CITY OF CORCORAN
Corcoran Planning Commission Agenda
August 6, 2020 - 7:00 pm

RE: **PUBLIC HEARING.** Nelson International Conditional Use Permit, Site Plan and Variance for the property at 10409 County Road 101 (PID 01-119-23-41-0001) (city file no. 20-022)

Subject: Nelson International – Plan Review Comments

PHOTOMETRIC PLAN

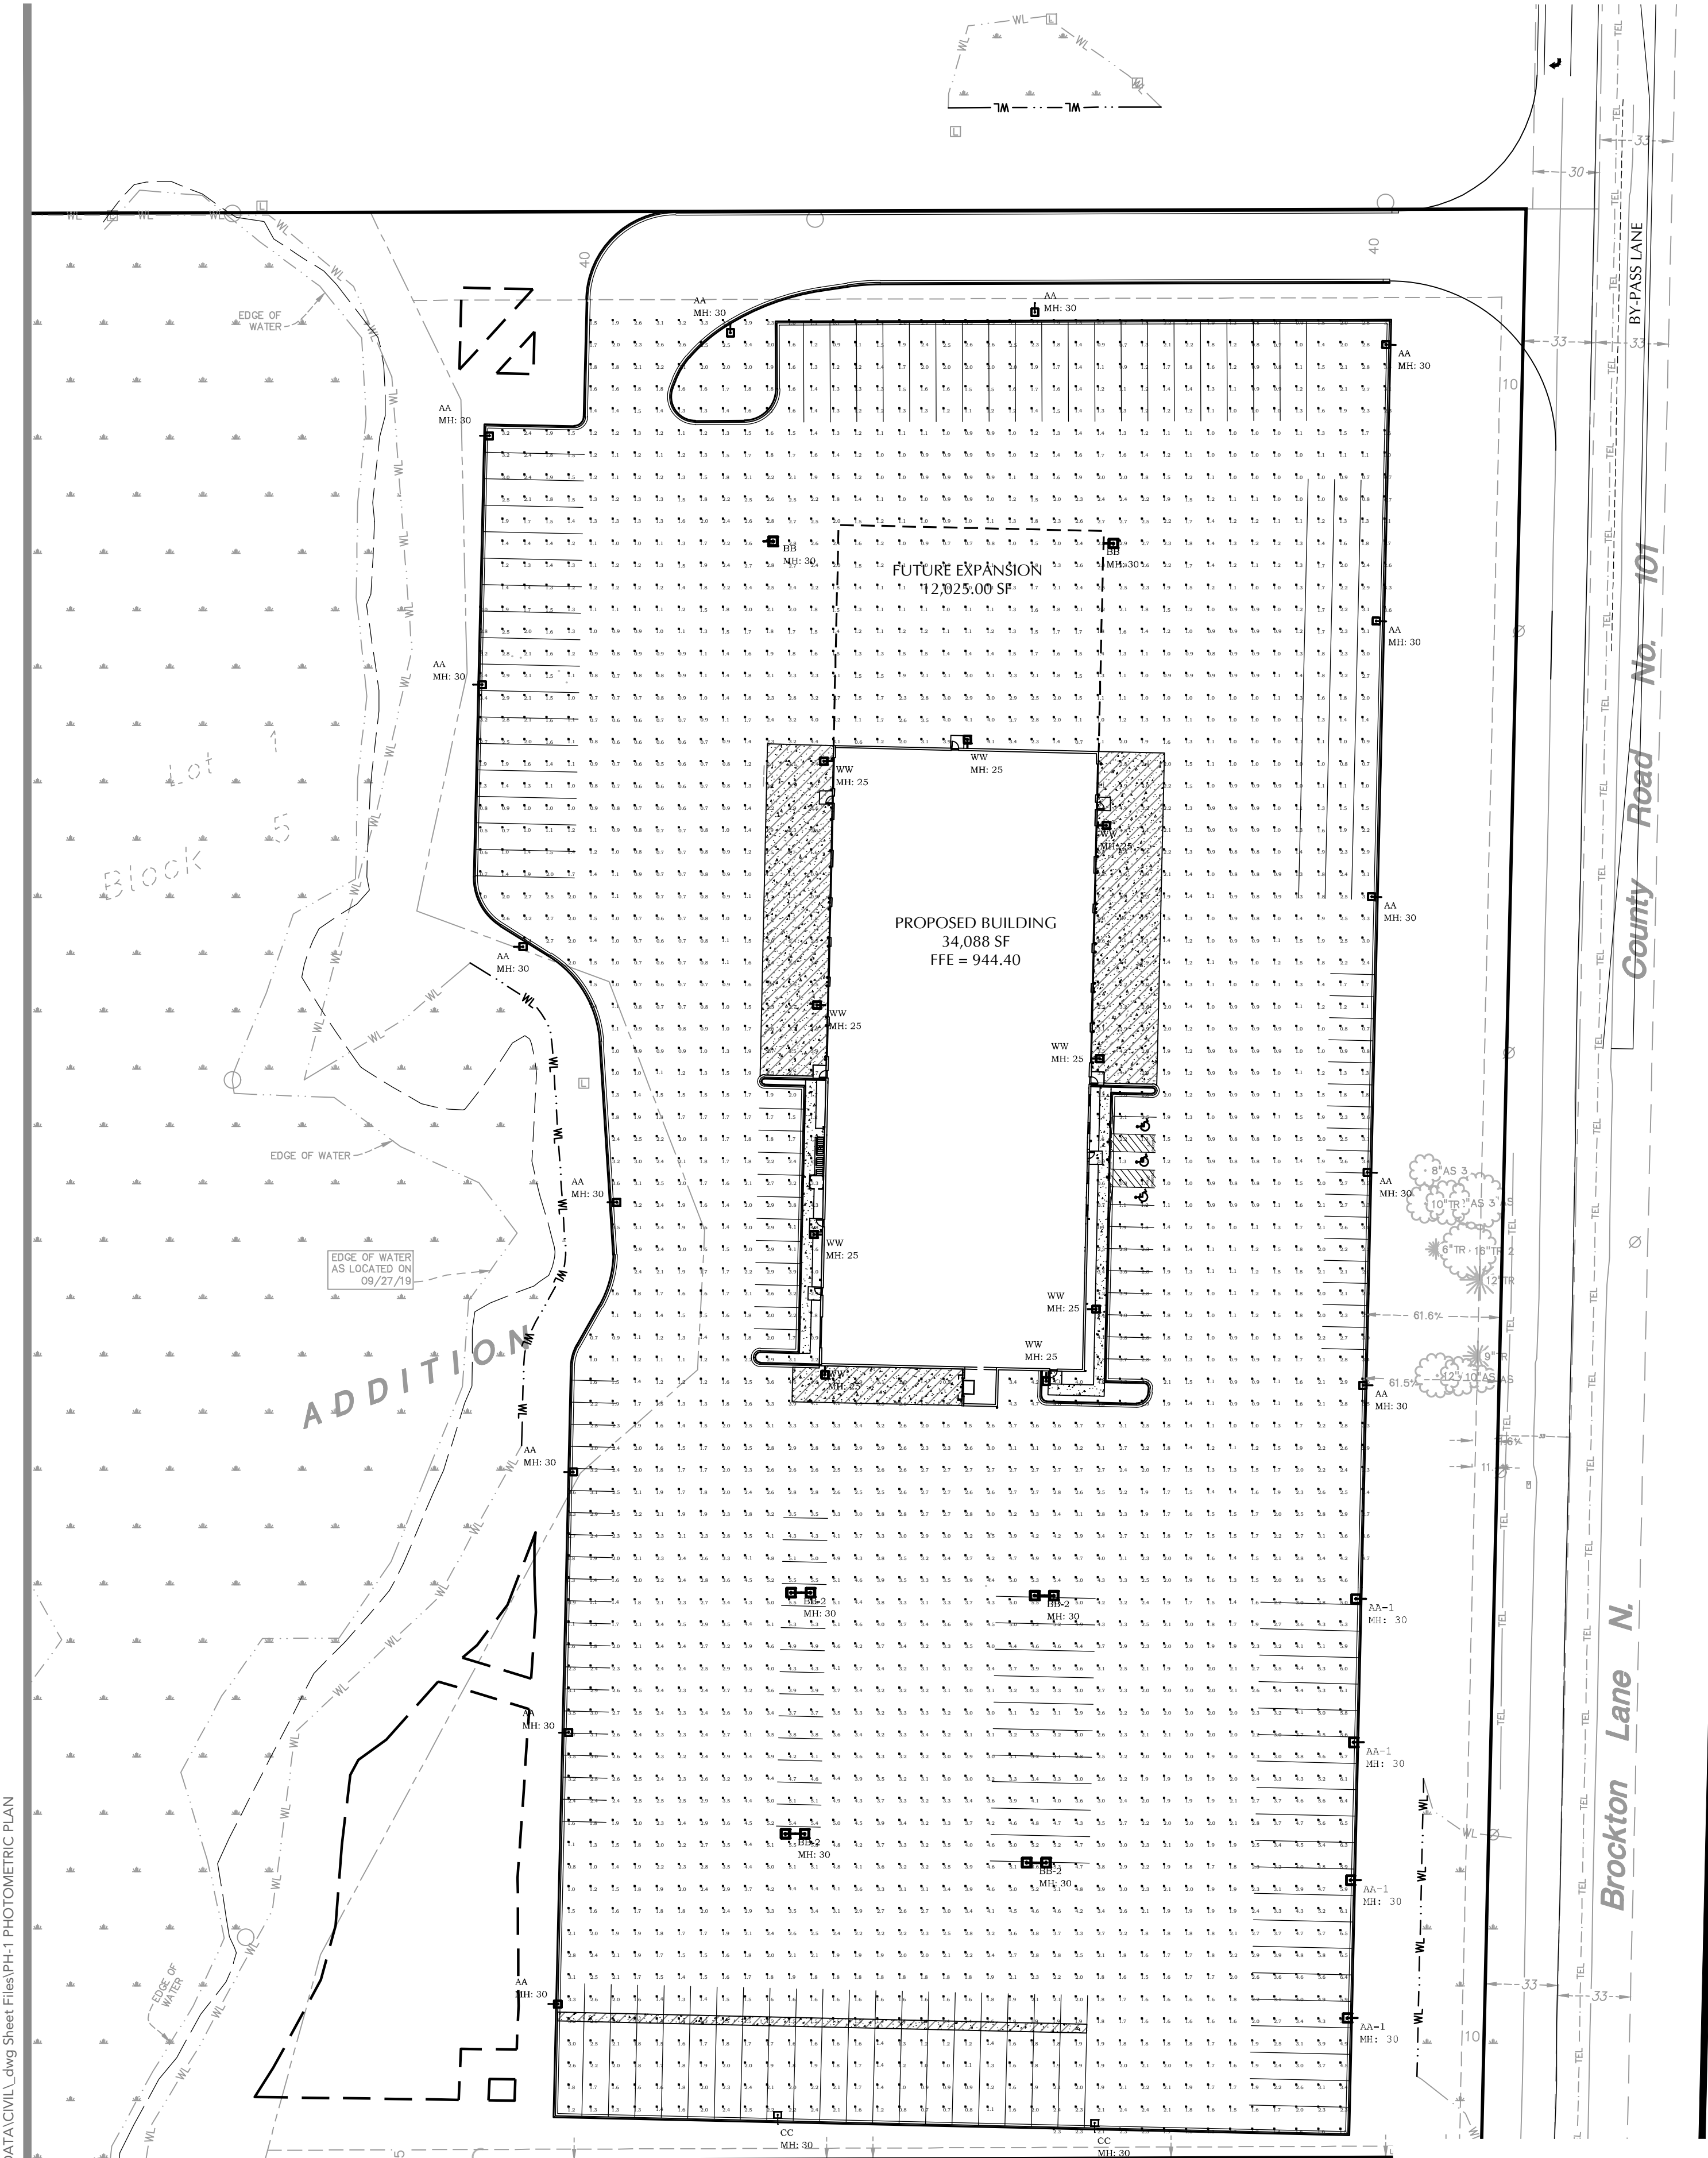
The applicant has submitted a photometric plan that seems to be in compliance with the Zoning Ordinance. The applicant has not supplied detail sheets on the light fixtures that will be used. Staff has included a condition that the applicant must provide detail sheets on the fixtures to be used and the applicant must be in compliance with Section 1060.040.

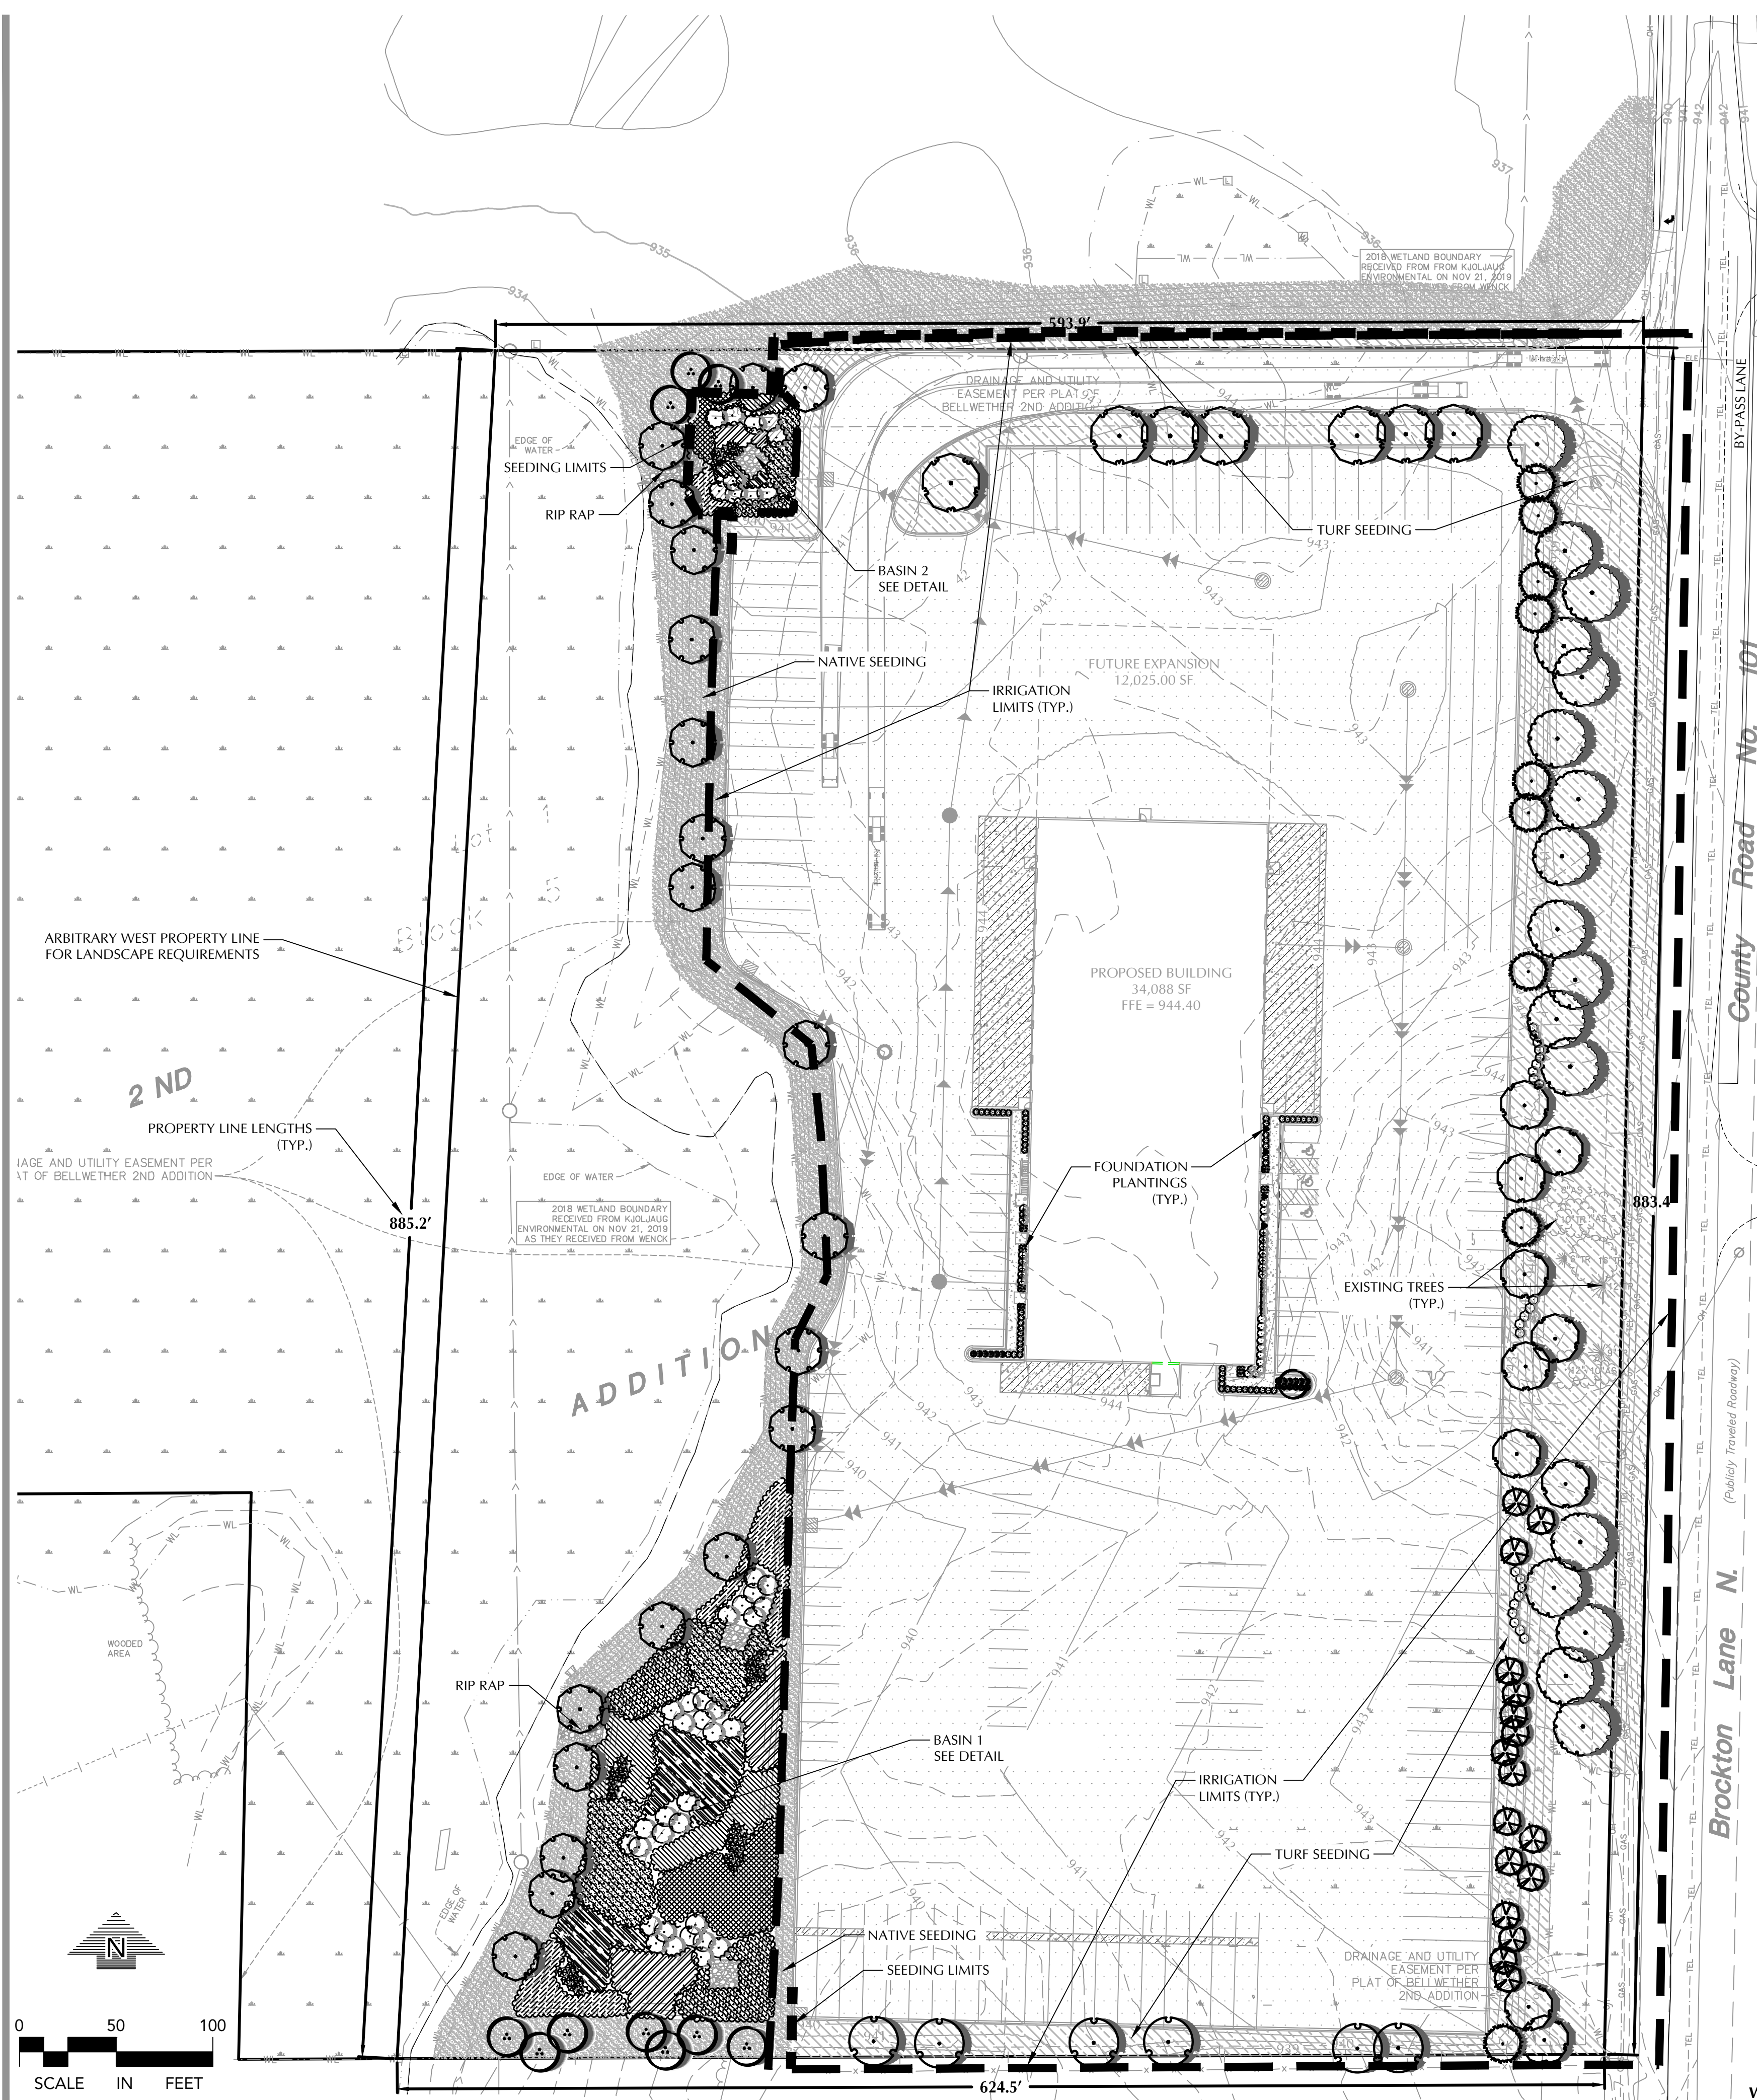
The applicant’s landscape plan is generally consistent with ordinance requirements by providing landscaping around the buildings and parking lots. The applicant would be required to provide 59 overstory trees and 161 understory shrubs or the equivalent to meet basic requirements. The plans appear to comply but must be updated to ensure compliance.

The applicant has shown additional overstory, ornamental and understory trees in order to allow reduced setback flexibility on CR 101, but did not provide enough information to confirm that the requirements have been met. A total of 70 overstory deciduous trees, nine overstory coniferous trees, 18 ornamental trees, and 188 understory shrubs are proposed. Plans show only 17 of the proposed 18 ornamental trees. Staff has included a condition that the plans be revised. The plans show a symbol for the “Spring Snow Crabapple” ornamental tree, but the symbol is not present on the plans. Plans show shrubs on the plans, but the plans are illegible. Additionally, the table provided in the plans list only 184 shrubs. Staff has included a condition that the plans be revised. Staff suggests the landscape plans be revised to include inset that show the areas of the plan where symbols become too small to read.

Section 1060.070 of the Zoning Ordinance requires parking areas with 4 or more stalls shall be screened from properties zoned residential and from public streets. Screening should be at least three feet high to screen vehicle headlights. Plans should be revised to show this screening requirement.

Landscaping along CR 101 is currently conflicting with the proposed watermain. The watermain may not be installed immediately if the applicant is forced to go with the well option, but will be installed in the future and the landscape plan should be designed to reflect this work.

7. The landscaping plans must be revised to comply with the requirements in Section 1060.070 of the Zoning Ordinance:
 - a. Plans shall be revised to show additional screening along the southwest boundary of the parcel through either a combination of deciduous and coniferous trees or a combination of trees and fencing to buffer the parking, vehicle sales and overhead doors from the adjacent residential.

- b. The landscaping plans must be revised to the required number of shrubs.
 - c. The applicant must revise the landscaping plans to show the required number of ornamental trees for parking flexibility.
